Assessment of Dam Safety

Coal Combustion Surface Impoundments (Task 3)

Final Report

Belews Creek
Steam Station

FIGURE 4

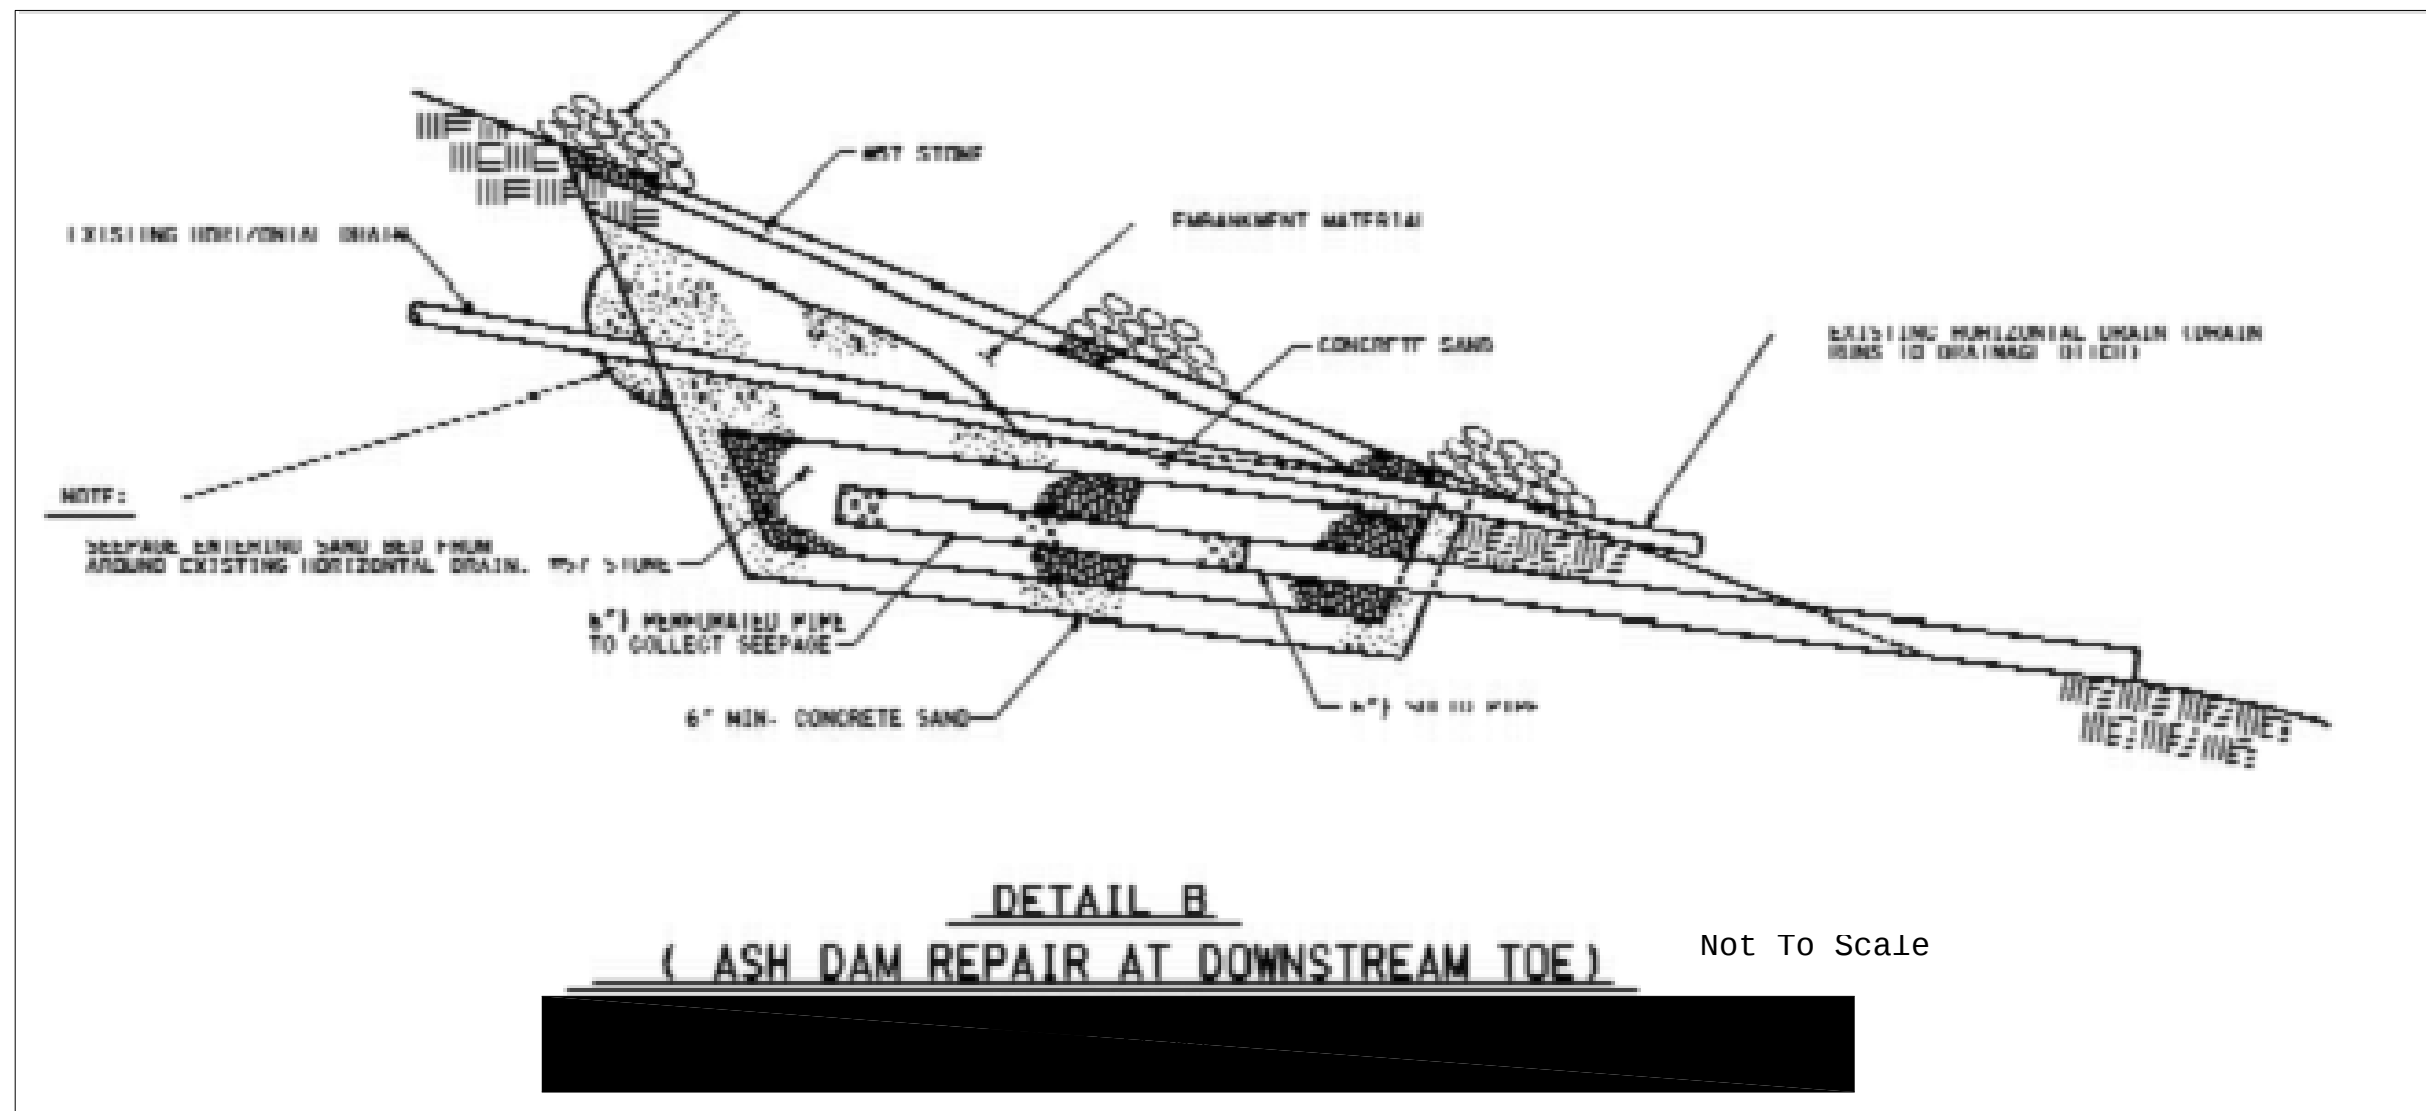
The construction drawings as shown in the cross section in Figure 4 indicate that the discharge pipe around the dike is a 24-inch SDR 17 pipe (smooth wall HDPE, 21-inch I.D.) that was installed as part of upgrades in 1984. The downstream end of the pipe terminates at Elev. 616

feet within a concrete impact basin which contains a Parshall flume (Photos 33 and 34). A rip rap stilling basin is present within the stream channel. The flume and stilling basin were observed to be clear of vegetation and unobstructed. The drainage course from the Ash Dike seepage controls joins the outfall watercourse below the stilling basin.
